EMAIL ROSEFIELD SOLAR FARM LTD TO CSAG 21ST JANUARY 2026

LOCAL DETERMINANTS AFFECTING HEALTH OF LOCAL POPULATION FROM PROPOSED ROSEFIELD SOLAR FARM

Photo 5 -Looking North West Towards Sion Hill / East Claydon Power Station

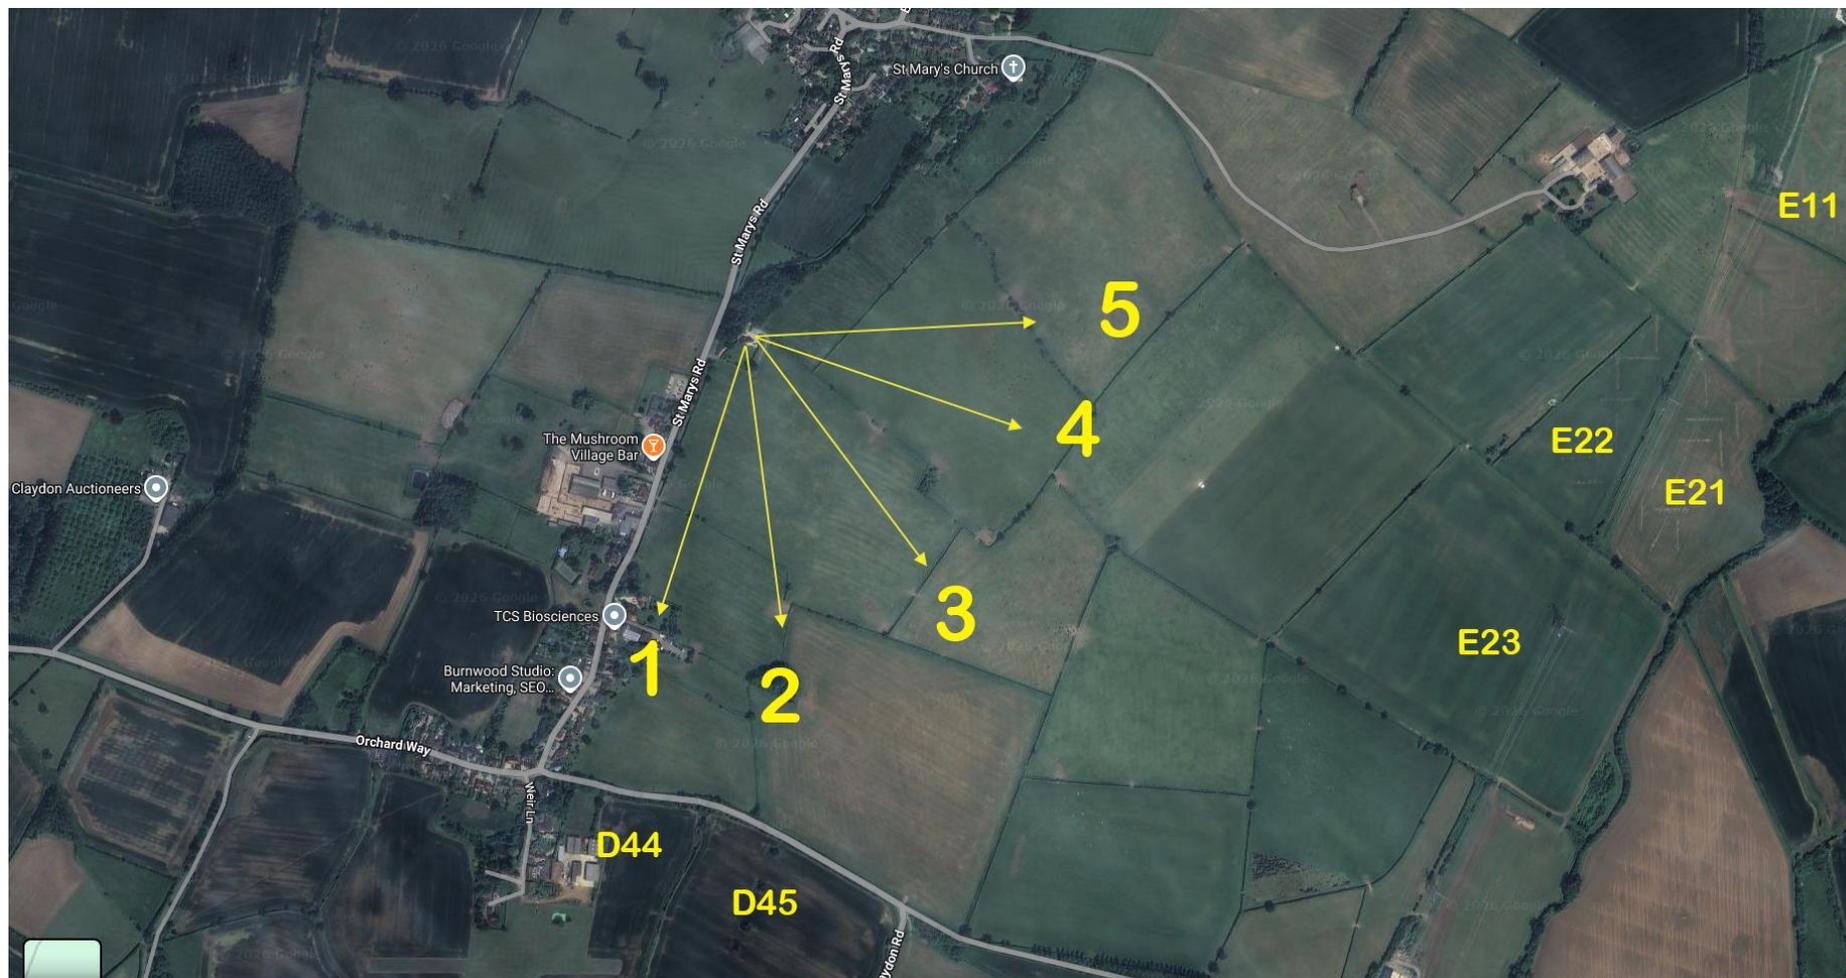
Images taken from bedroom windows of Ivy Nook.
